ACT vs TDD Comparison: Evidence Based Results

Contribution to 802.3dm Task Force

This presentation points out some of the errors in the presentation “ACT and TDD Comparison”, by Claude Gauthier and Frank Wang

EMC CISPR Results – BIG PICTURE

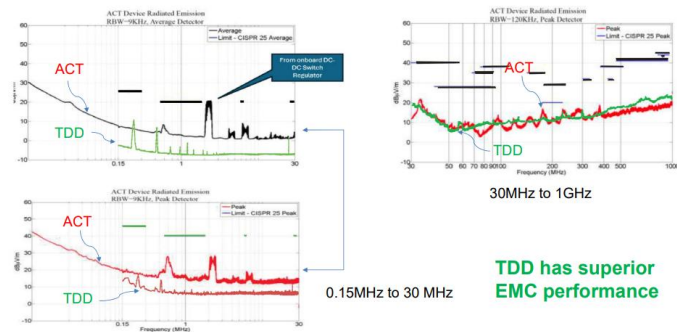
Misleading: What was timing, bandwidth, and frequencies for DL/UL tested?

Is this TDD or ASA?

If the above differs ASA is not TDD as specified [Evolution of 802.3dm: From GMSLE to ACT and Beyond](#)

Review **Slide 9** – TDD is Time driven ASA is Protocol driven

Overlay Comparison of EMC Results Presented at IEEE

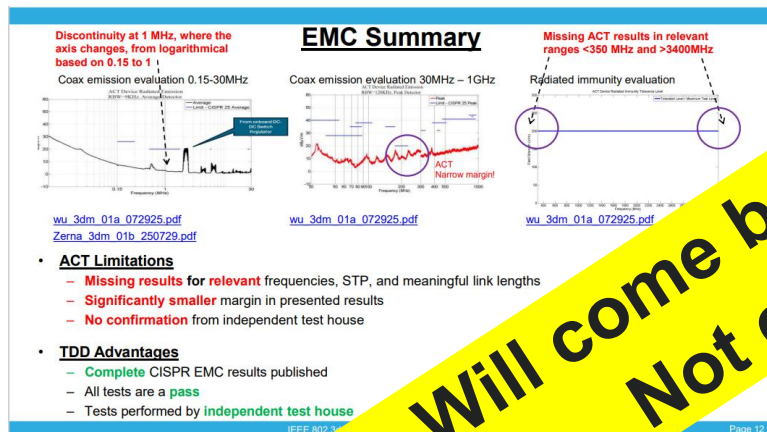
Misleading: Is this TDD or ASA? Please specify exact timing

Misleading: ACT tested Crystal-less and PoC – TDD did not

Review **Slide 3**

Incorrect: to compare the noise floor (where there are no peaks) between different CISPR25 measurements.

The noise floor depends on the equipment used in the test (LNA noise figure, spectrum analyzer type), independent of the modulation type.

Misleading: Radiated emissions is very dependent on board and cable type.

It is not valid to compare different test setups for relative performance.

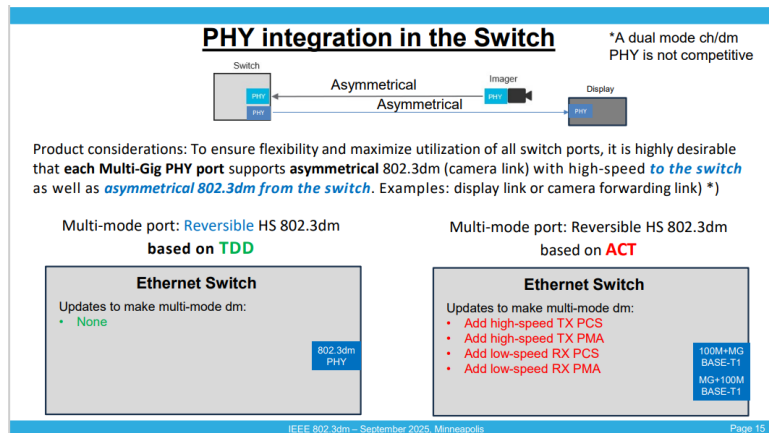
Misleading: This is a implementation decision and not a part of PAR

PHYs are fixed during production

Why would display and camera ports be changing in production?
This is a physical link and PHY would be optimized per customer application

Incorrect: This is a disadvantage for TDD when comparing optimized ACT product

Misleading: TDD has 1 additional FAST TX and FAST RX per PHY with this application

This is a large increase in die size will double the die size of an ACT optimized PHY

Crystal-less Summary

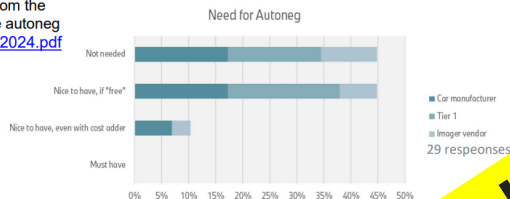
Incorrect: Differential Manchester Encoded (DME) modulation is a mature and robust method which has been used for decades in communications

Incorrect: Clause 98 is an optional part of the ACT proposal and has nothing to do with ACT crystal-less operation

Incorrect: Incoming signal does not have better jitter properties than a DME ACT signal with proper timing recovery.

PHY-level Sync

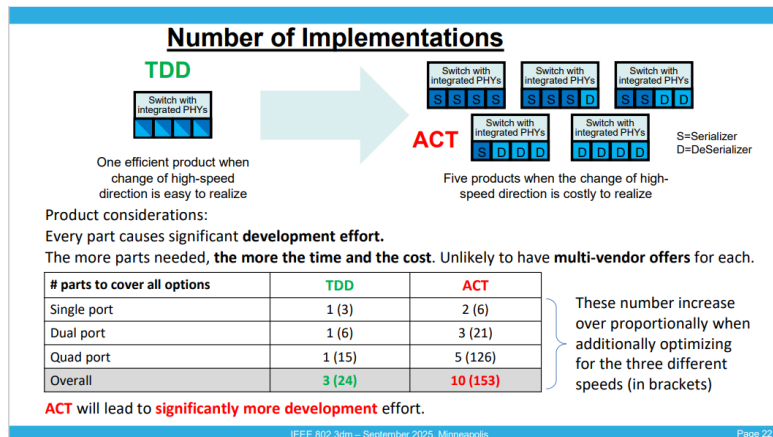
Delay compensation is a feature that can be implemented in ACT. SERDES accomplishes delay compensation without TSN

This is a implementation decision and not a part of the 802.3dm PAR

This is not unique to TDD – this is copied from SERDES which invented this feature

ACT does not require hardware and software changes it has built in low latency behavior

Incorrect: TSN is not required for ACT

Incorrect: ACT GPIOs are fast acting stated last September (Hamburg) and was the reason ASA-MLE did not move forward and TDD is now proposed, due to latency issues.

Where did the 5.3ns accuracy come from? No link or calculation or method explaining.

No reasoning behind why this is needed for customers and more importantly why the standard needs this
